Enclosure 5 to E-54422

**SAR Changed Pages
(Public Version)**

Figure 2-16
WCS CISF Cross Section West-East

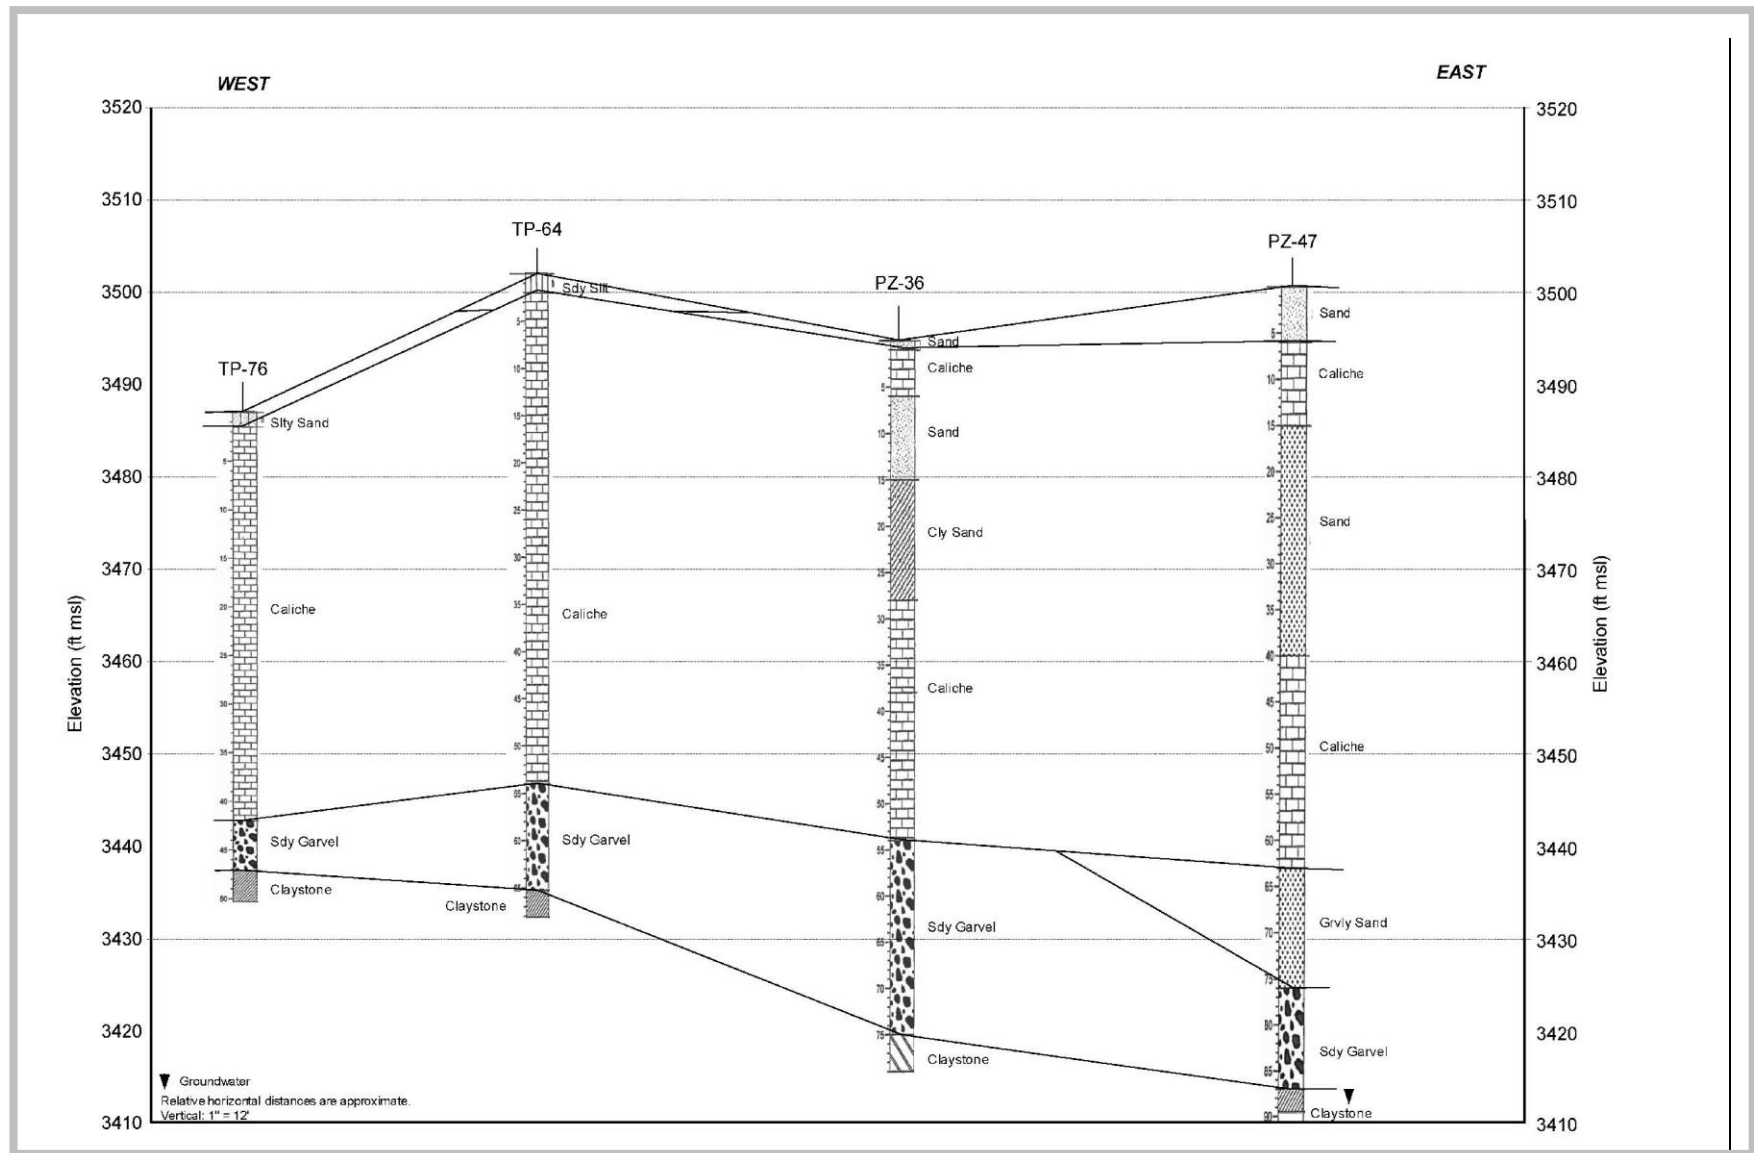
Two cross sections in the vicinity of the WCS CISF were created using boring logs from former site investigations. The locations of the cross sections are shown on Figure 2-15. Two cross sections in the vicinity of the WCS CISF are included as Figure 2-16 and Figure 2-17 and the associated boring logs are included in Attachment C.

As a consequence, Gatuña is not present at the CISF site. The depth to the top of red beds at the CISF is approximately 50 to 80 feet, based on the logs of borings shown in Figure 2-15, Figure 2-16 and Figure 2-17. The northward slope gradient of the top of the red beds across the CISF ranges from approximately 0.98% (based on red bed elevations between TP-64 (3435 ft msl) and PZ-46 (3414 ft msl) and 0.84%, based on red bed elevations between TP-65 (3437 ft msl) and PZ-47 (3414 ft msl). At the CISF, the maximum apparent slope on the late Pliocene erosional surface of the red beds is 1.77%, between TP-84 (3432 ft msl) and PZ-36 (3419 ft msl).

In the immediate vicinity of the WCS facility, the axis of the red bed ridge occurs from approximately the northwest corner of the Byproduct landfill to the southeast corner of the Compact Facility, continuing southeastward beyond the WCS landfills. The axis is not located under the CISF area. The nearest location of the crest of the buried ridge to the CISF is approximately 1200 feet south along State Line Road. At this location, the depth to the crest of the red beds is about 34 ft, based on the log of boring B-1 in Figure 5-4 from WCS (Waste Control Specialists LLC, 2007 [2-43]). The elevations of the top of red beds are estimated from Figure 2-16 and Figure 2-17, with locations estimated from Figure 2-15 and Figure 2-35.

Figure 2-37
Geologic Column of the WCS CISF Area

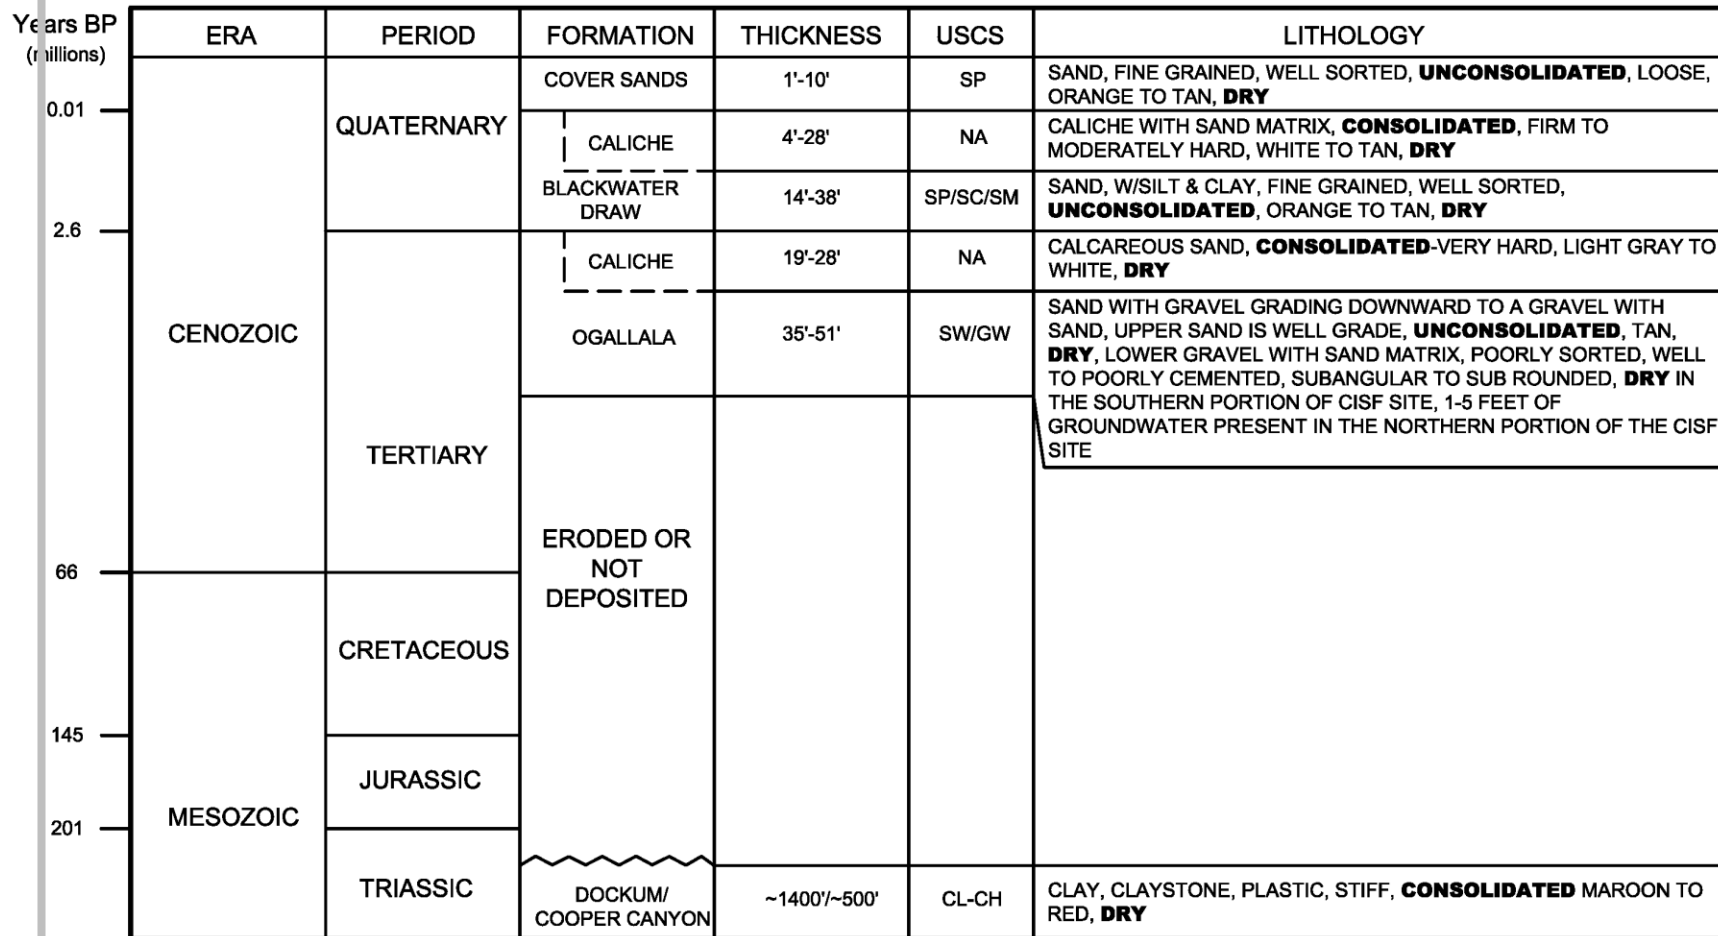
A stratigraphic column of the WCS CISF area for the above units is provided in Figure 2-37. This CISF site-specific stratigraphic column was developed from data collected from site boring logs. The boring logs are presented in Attachment C.
